General

30 MAR 2012

Running Rendezvous

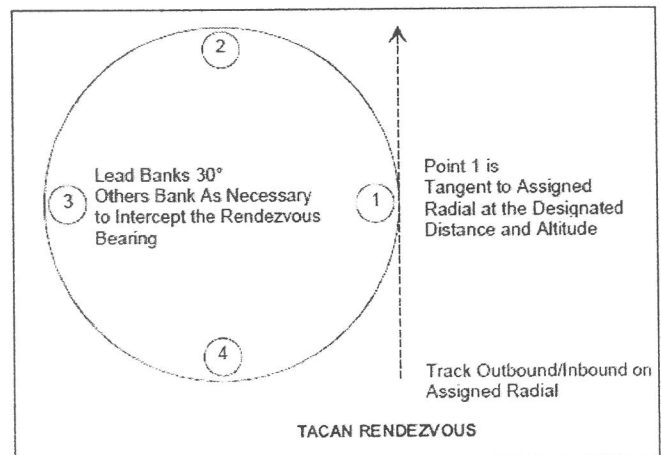
D6. Update Section 502, Paragraph 5: Delete Paragraph 5 and replace with:

The running rendezvous is used to join a flight that is proceeding on course. Following takeoff, Lead will climb out via course rules, accelerating to 140 KIAS. Wing will accelerate to lead's airspeed plus 30 KIAS to control rate of closure. The wingman should exploit any turns by cutting inside of lead's turn radius and converting to a CV rendezvous. The wingman should set an abeam distance from lead of about 5 plane widths. If too wide of a distance is chosen, the wing will arrive on the 45 degree bearing line with too large of a distance to close, delaying the join up. If too tight, the wing will not be able to perceive closure. Once established on the 45 degree bearing line, wing will ride the bearing line into starboard parade. This is a

demanding maneuver do the lack of perceived relative motion in the initial stage. When relative motion first appears, reduce power to control closure rate. If excess closure develops and cannot be controlled safely, wing shall execute an underrun. When joined, report, "Two is aboard starboard". Lead shall begin transmitting maneuver commands at this time. During course rules departures, lead may transmit, "Hang with me" in lieu of separate maneuver commands.
